UNITED STATES
NUCLEAR REGULATORY COMMISSION
WASHINGTON, D. C. 20555

The Commission has issued the enclosed Amendments No. 12 to Facility Operating Licenses Nos. DPR-32 and DPR-37 for the Surry Power Station, Units 1 and 2. The amendments include Change No. 27 to the Technical Specifications for each license and are in response to your request dated October 22, 1975.

The amendments revise the provisions in the Technical Specifications relating to the heatup and cooldown limitations of the reactor coolant system.

CHANGE NO. 27 TO TECHNICAL SPECIFICATIONS

TS FIGURE 3.1-1
NOV 21 1975

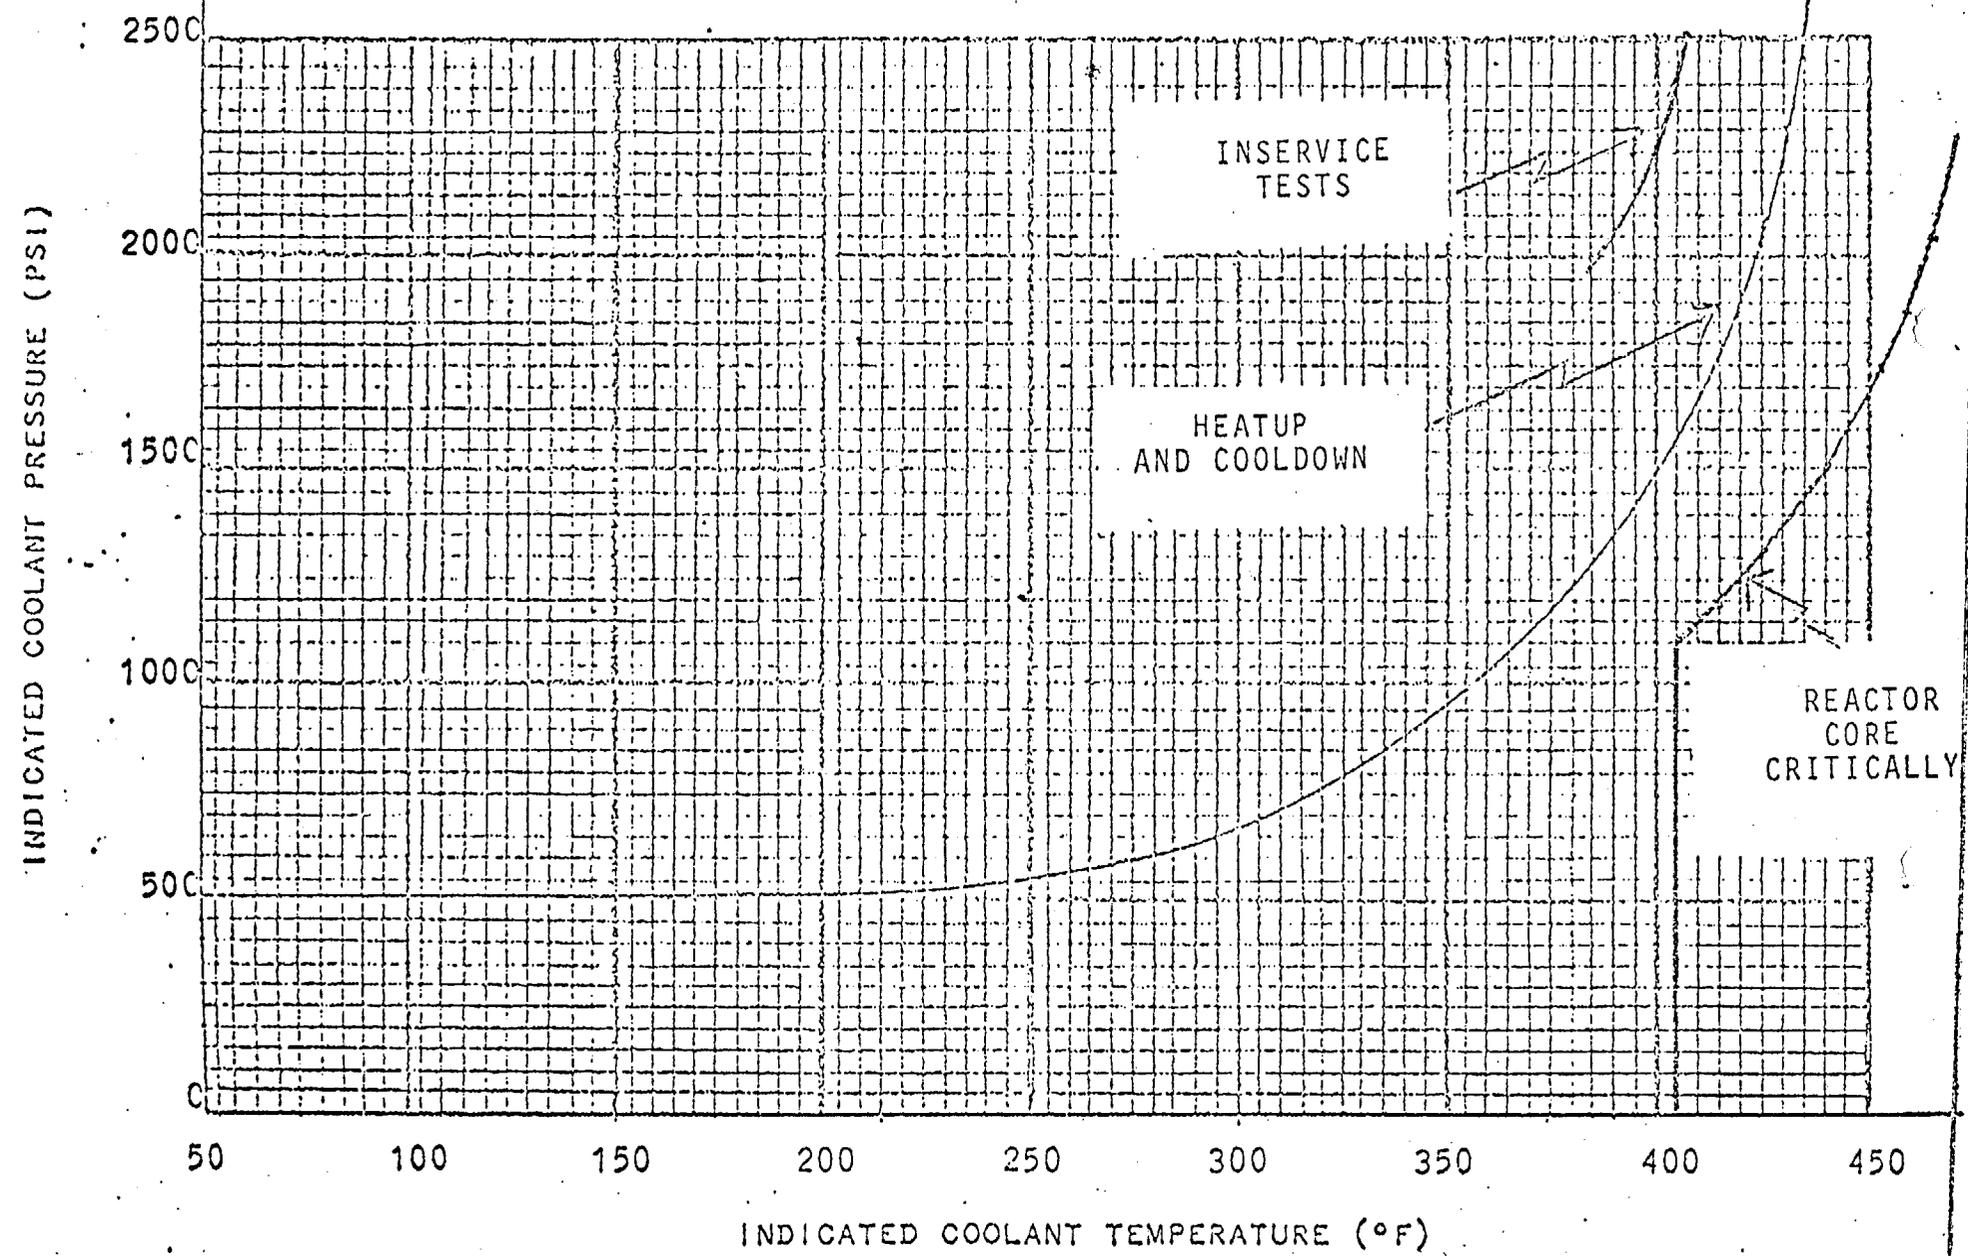
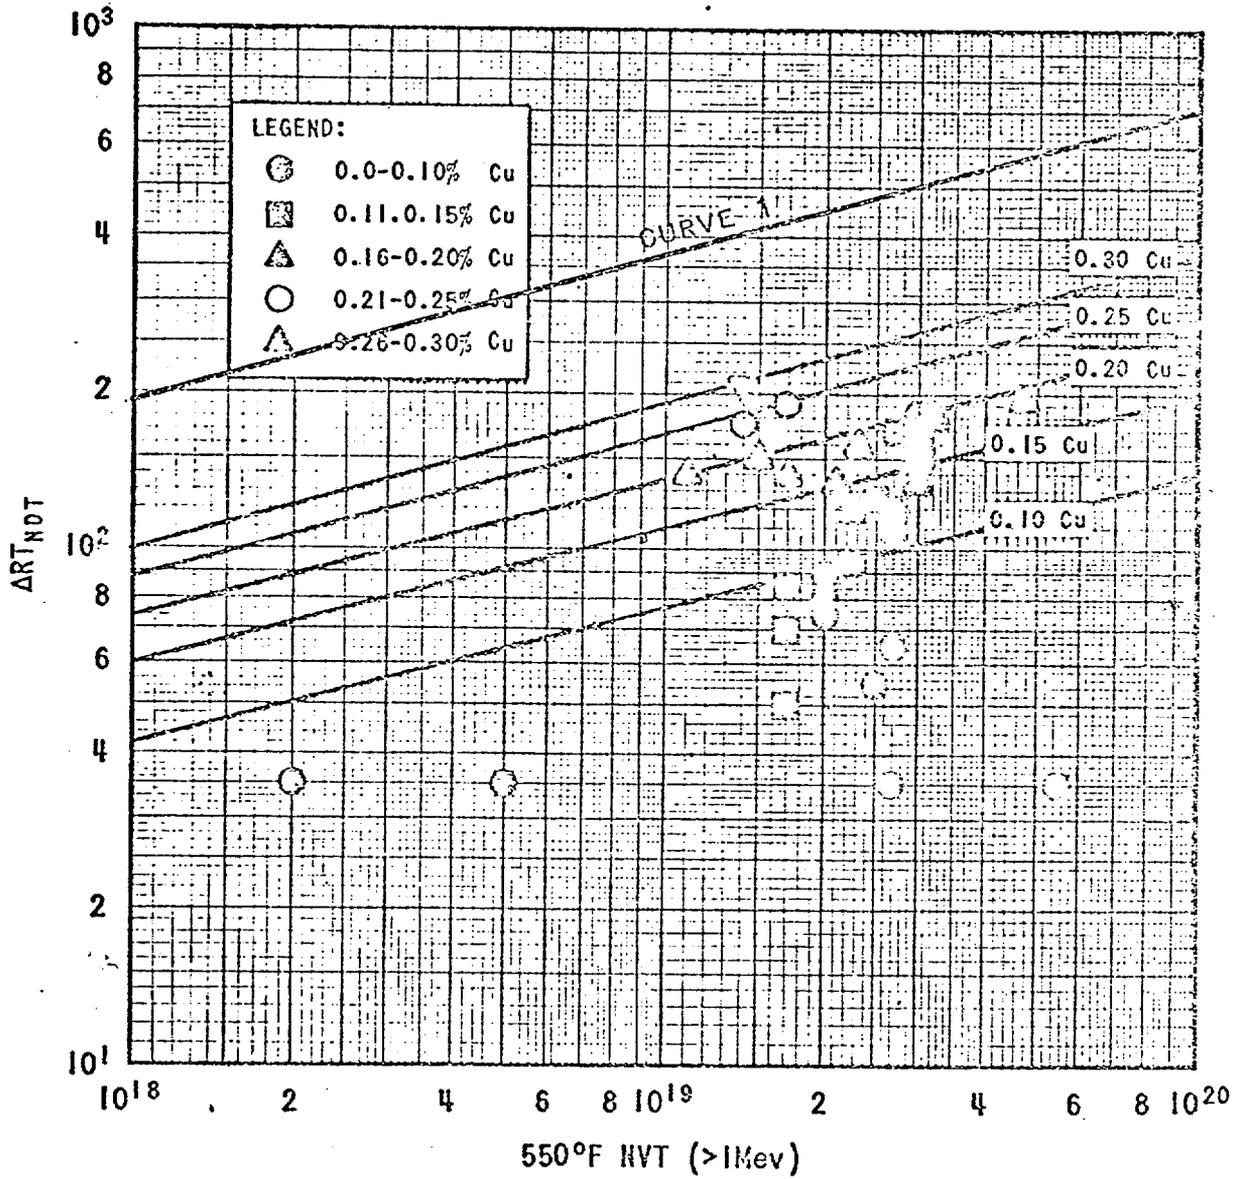
We have evaluated the pressure-temperature limit curve presented in Figure 3.1-1 of the licensee's proposed Technical Specification Change of October 22, 1975 and conclude that it is acceptable for heatup and cooldown pressure-temperature limits. We have augmented this curve to indicate pressure-temperature limits for inservice hydro testing and core criticality. The attached curves provide acceptable limits for these conditions.

The following paragraph has been added to Specification 3.1.B.1:

"Core Operation:

During operation where the reactor core is in a critical condition (except for low level physics tests), vessel metal and fluid temperature shall be maintained above the reactor core criticality limits specified in Figure 3.1-1."

The following statement has been added to Specification 4.3.A:

"The pressure-temperature limits for these tests will be in accordance with Figure 3.1-1."

The pressure-temperature limits for inservice tests, heatup and cooldown and core operation contained in the licensee's Technical Specification Change of October 22, 1975 with the above revisions comply with the requirements of Appendix G, 10 CFR Part 50 and are acceptable. The use of Appendix G in establishing safe operating limitations will ensure adequate safety margins during operation, testing, maintenance and postulated accident conditions and constitute an acceptable basis for satisfying the requirements of NRC General Design Criterion 31, Appendix A, 10 CFR Part 50.
